Hydrocarbon Recyclers, Inc. of Wichita EPA ID Number KSD007246846

Part B Permit Application

Corrections to Building I Containment

Figure D.2. Material Containment Areas

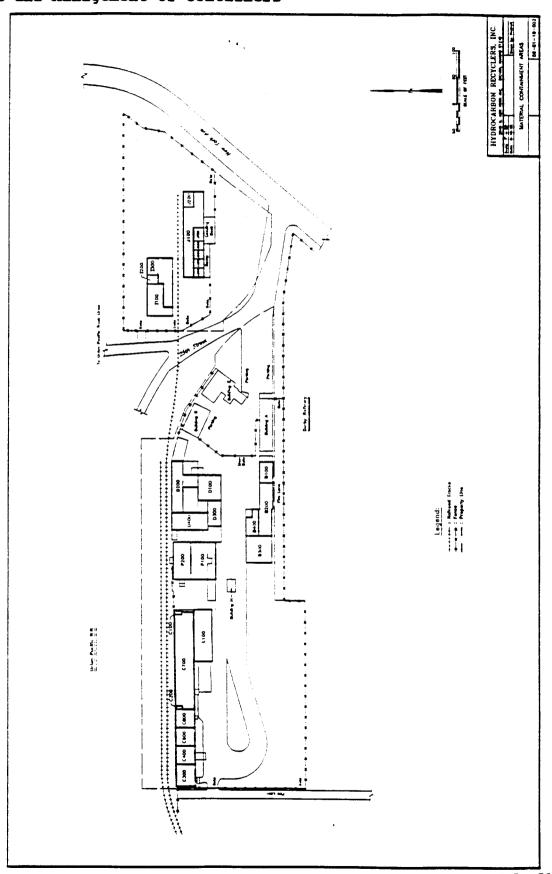
Building I is designed with three (3) CMUs (I100 through I300) which are diked or walled to provide secondary containment. The layout of Building I is shown on Figure D.8 (Drawing 50-17-10-001), presented in Appendix D-A. The CMUs are designed to meet the storage requirements for RCRA regulated wastes, to promote sound container management practices, and to minimize the potential for a release of hazardous waste into the environment. The CMUs are constructed of concrete floors and diking, and concrete block walls. Seams in the floor are sealed using water stops.

a plan for SAFETY EQUIPMENT to the Hydrocarbon Recyclers, Inc. a Division of USPCI located at 2549 N. New York Ave. Wichita, Kansas 67219

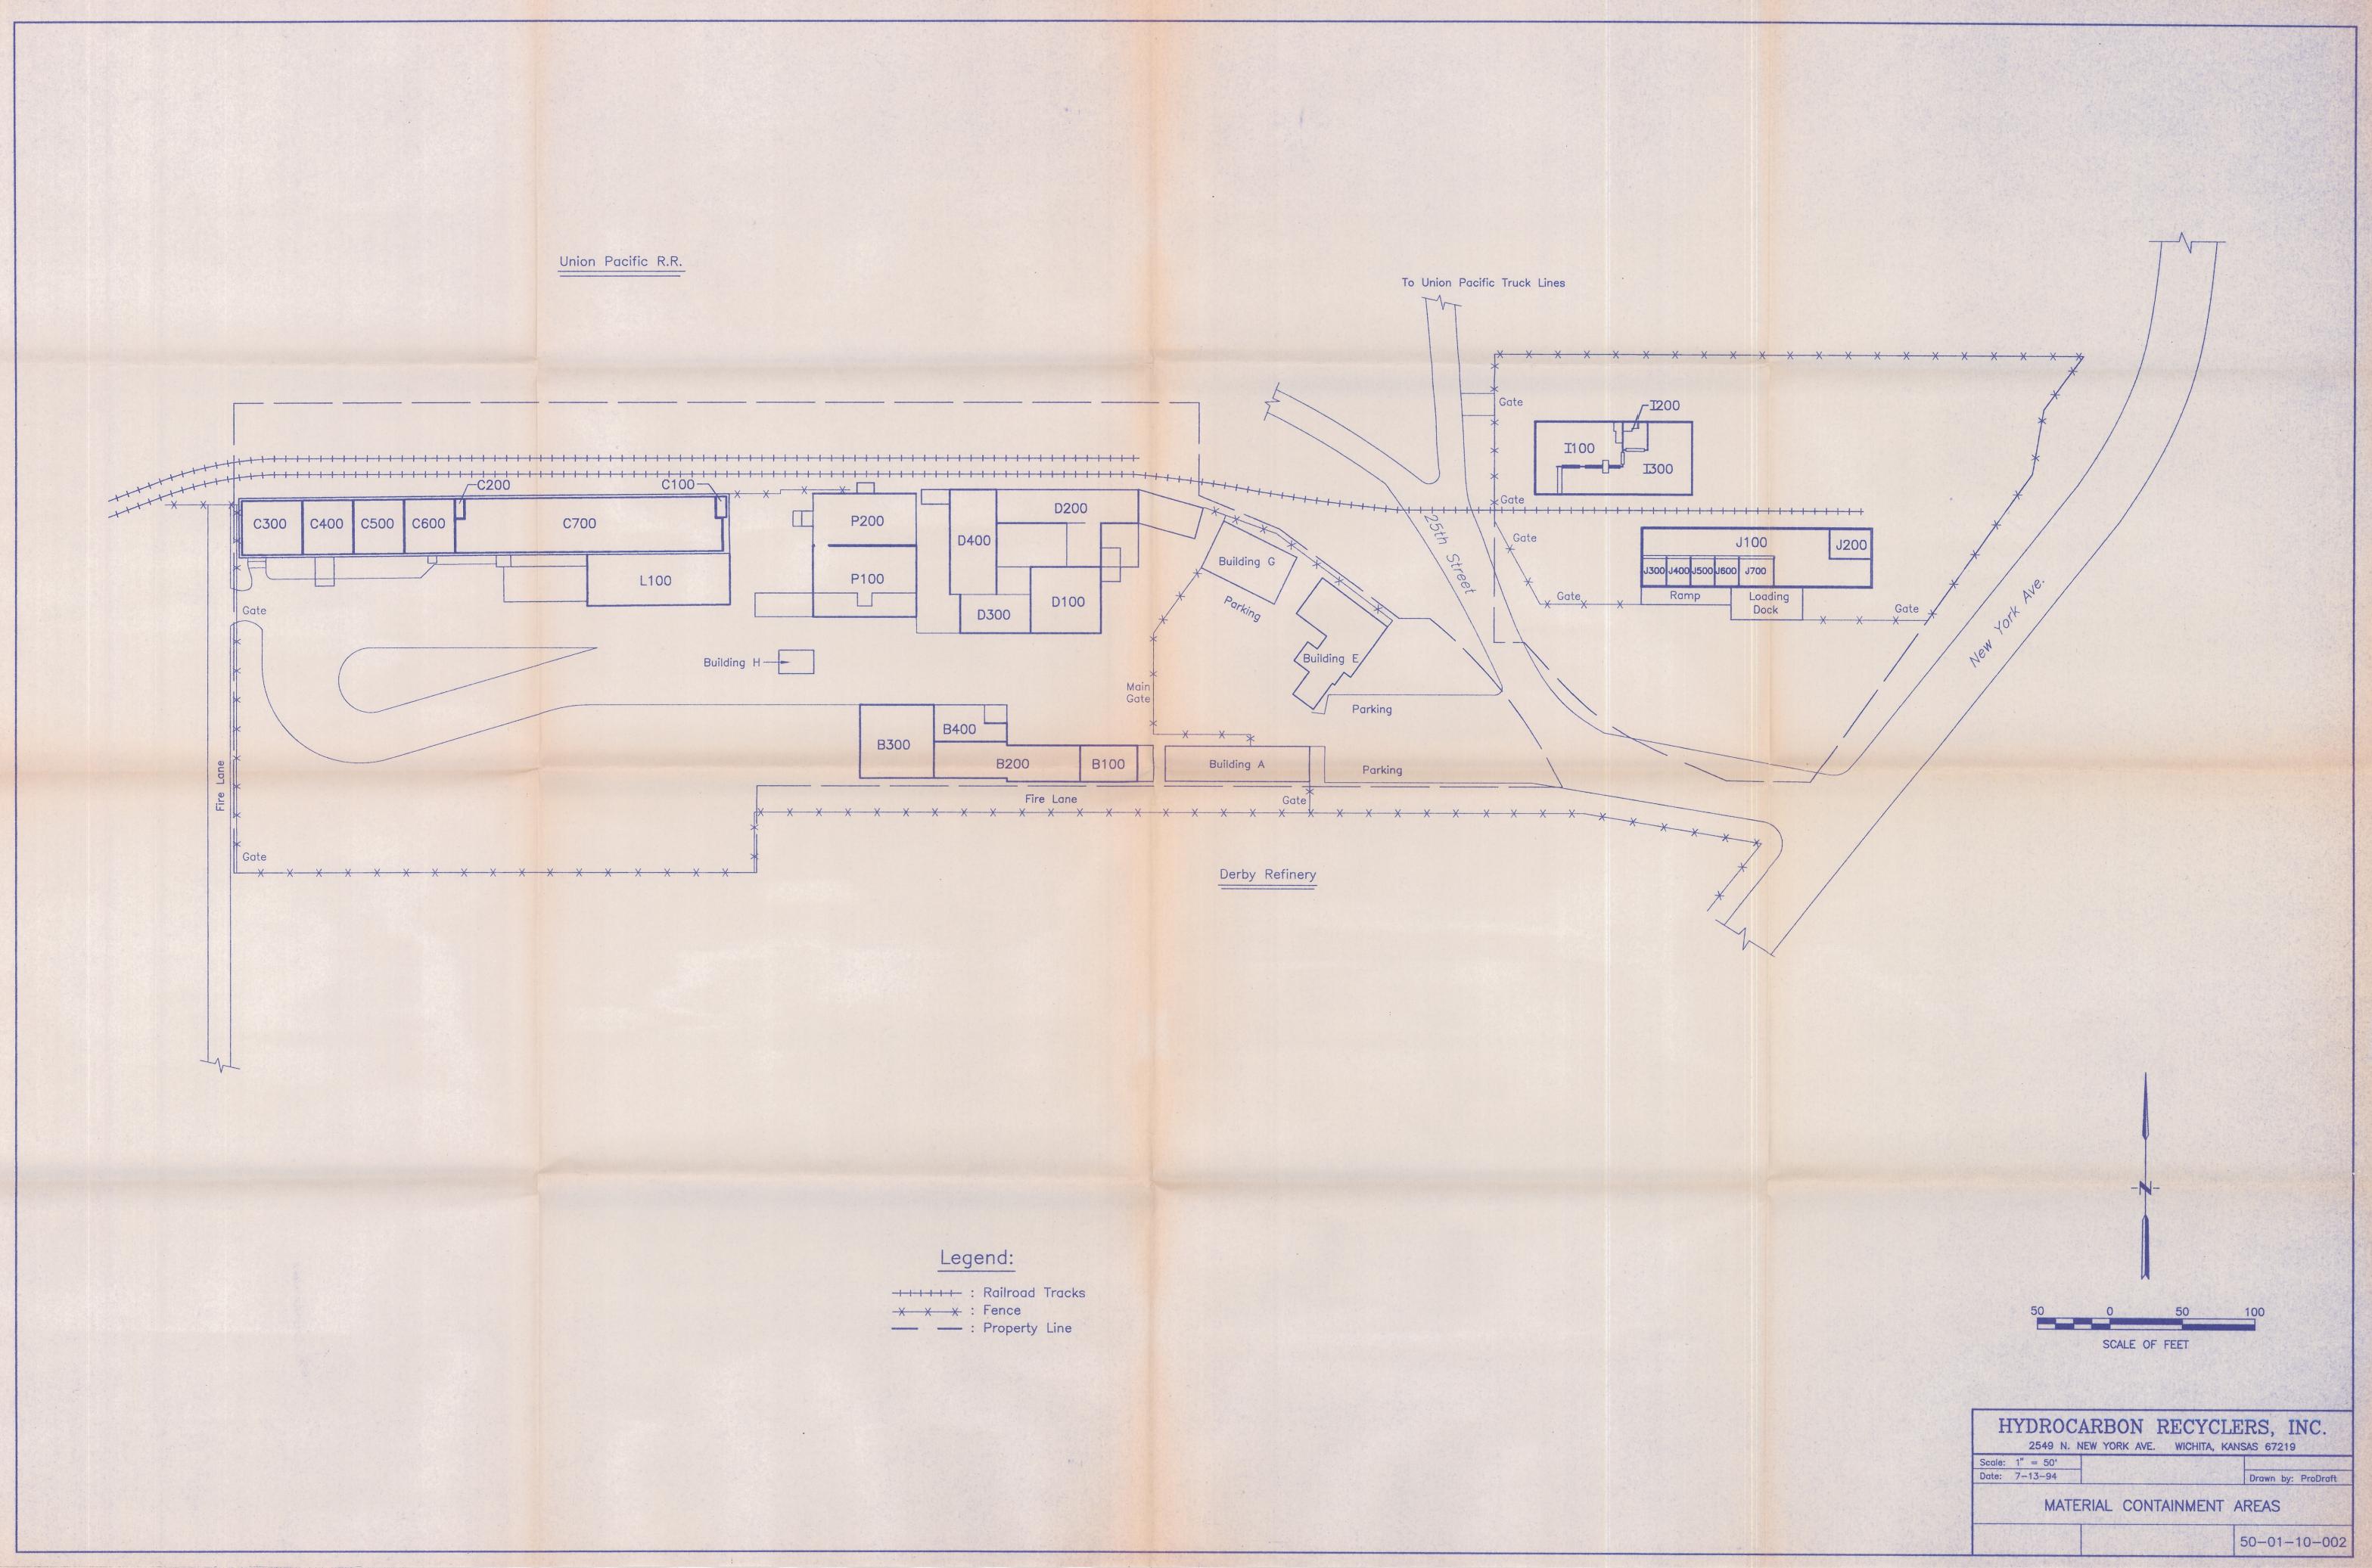
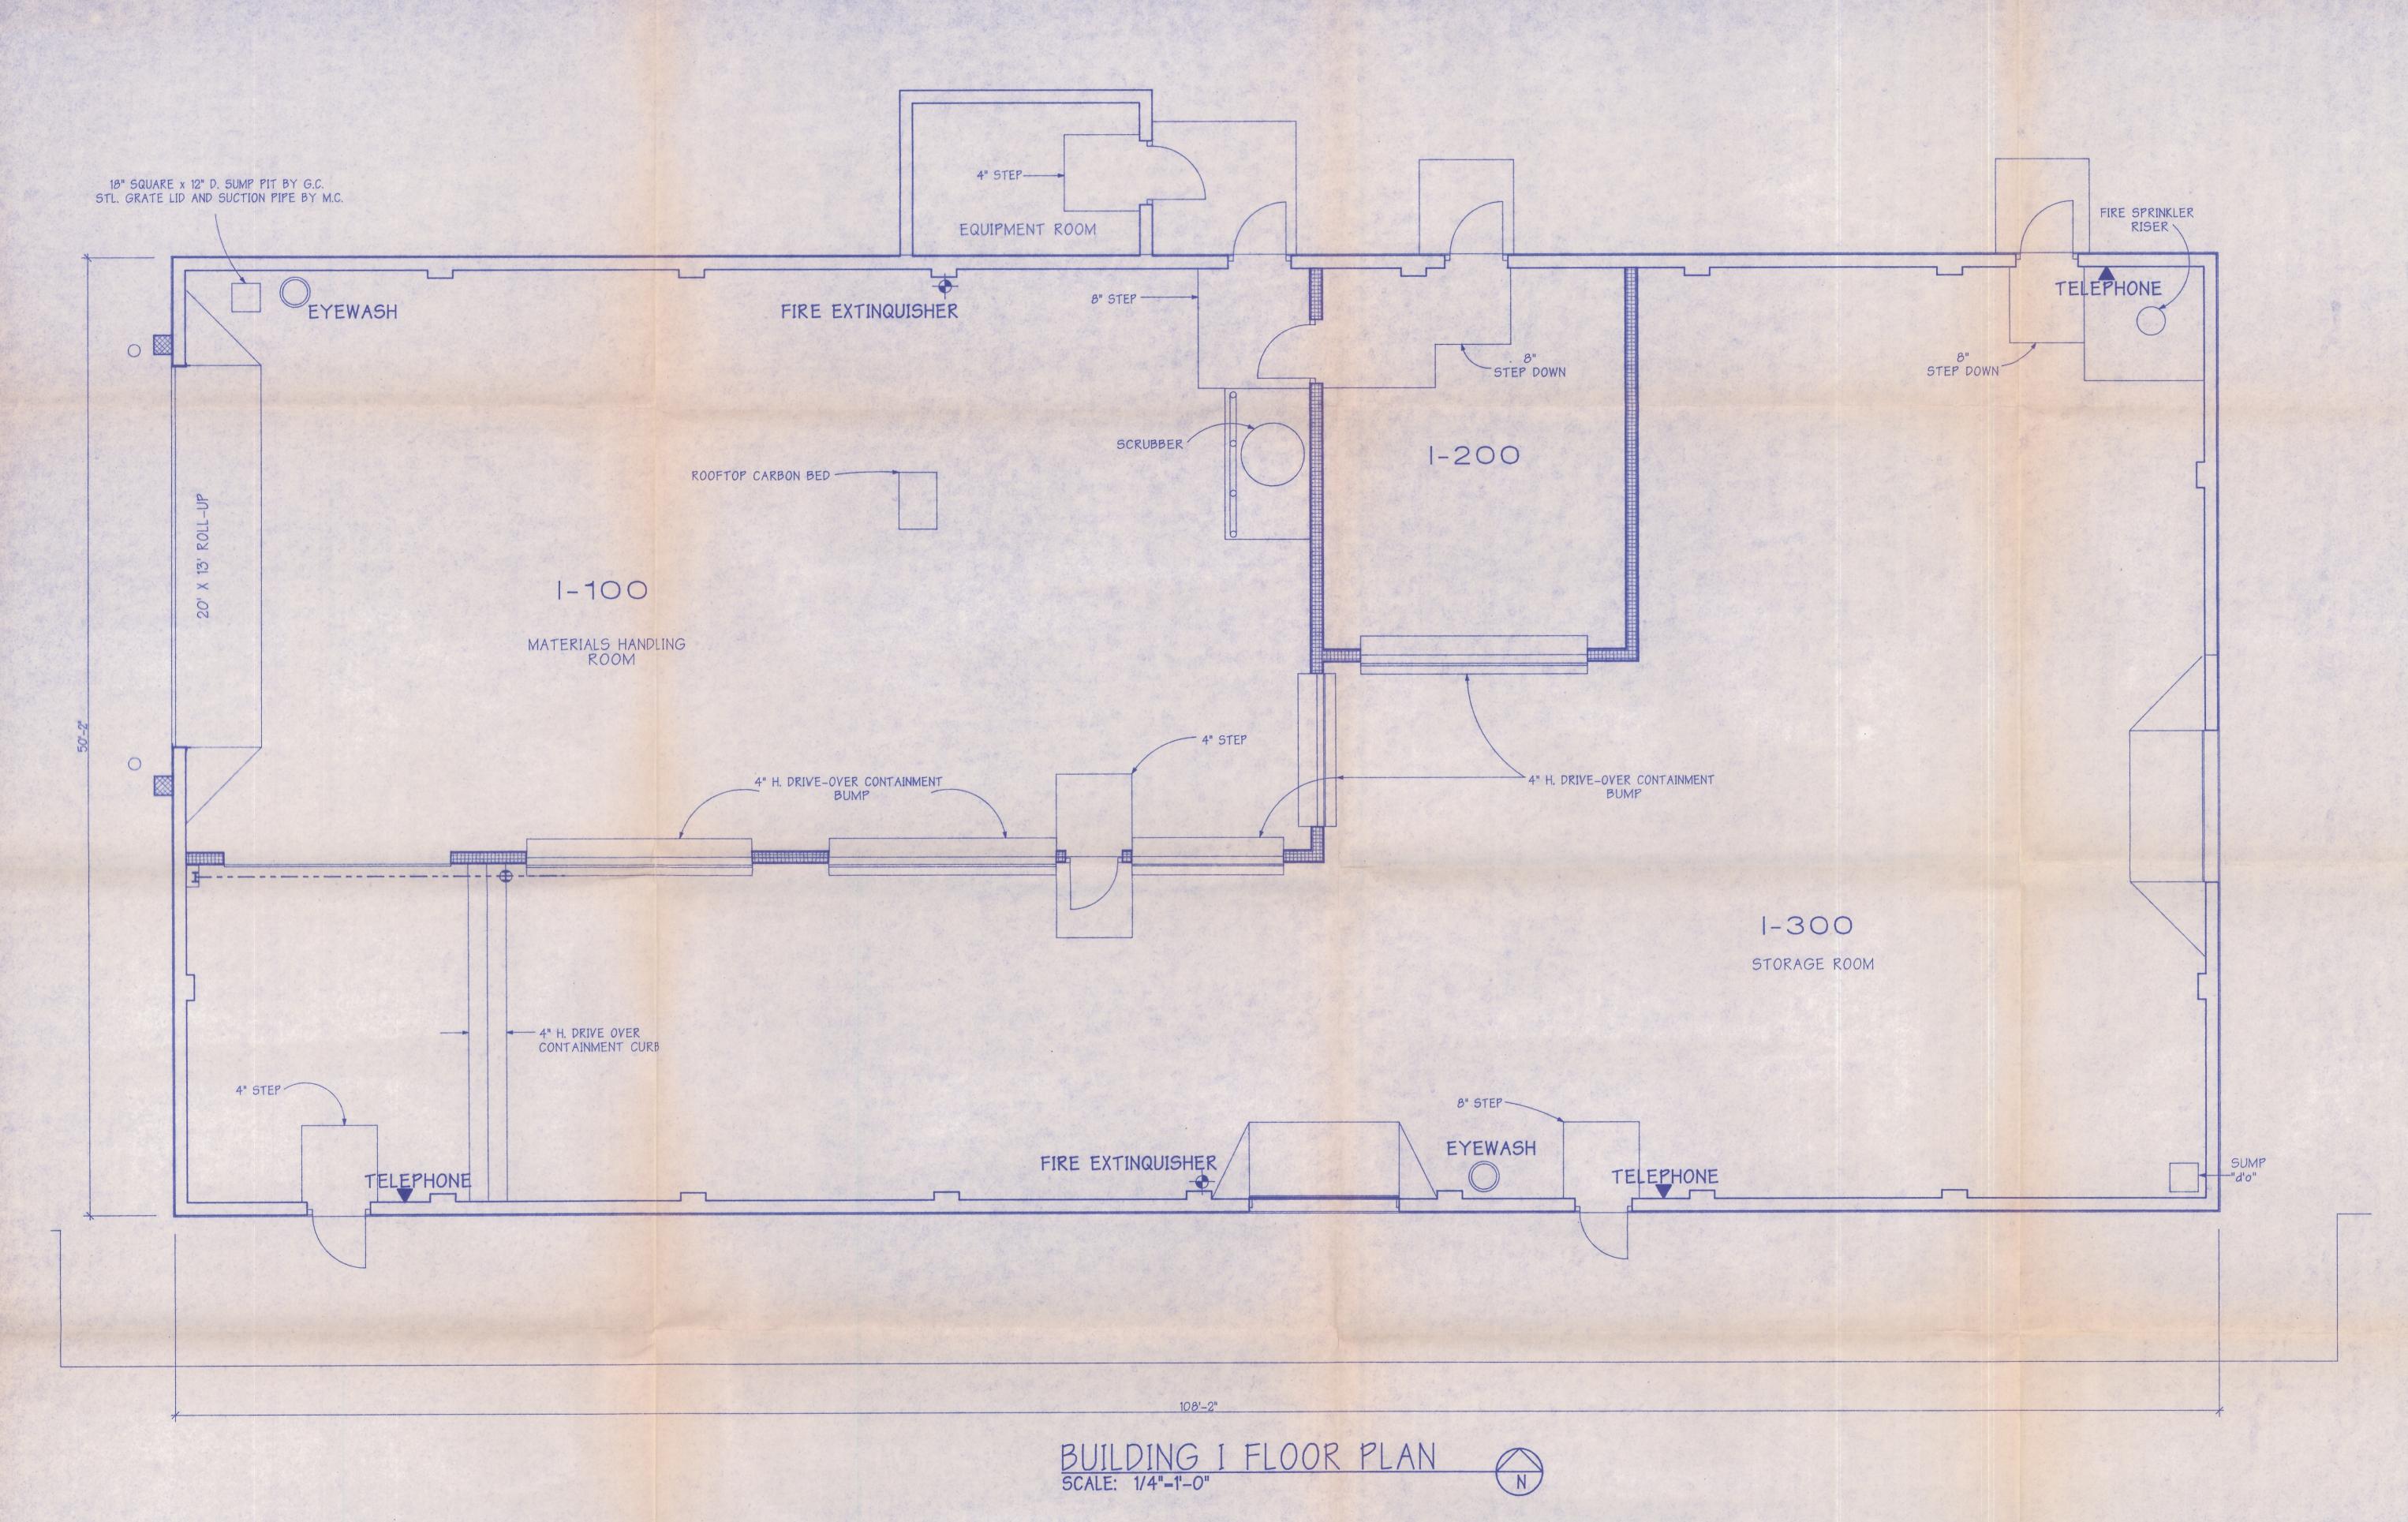
- The only page changed in Section J is the second page of Appendix J-1 (page 66 in the text).
- Drawings numbers 50-17-10-001, 50-01-10-002, 50-30-3-001, and the "I-Building Safety" drawing have been changed, and will need to be replaced in Section Y, Referenced Drawings. Reduced copies of these drawings are also included for insertion into the text.
- The reorganization of container management units (CMUs) in Building I from four units to three units has necessitated the recalculation of the containment volumes, although it has not changed the total waste storage volume for the building. The new calculations for CMUs I100, I200, and I300 are provided for insertion into Appendix D-B, Attachment 6.
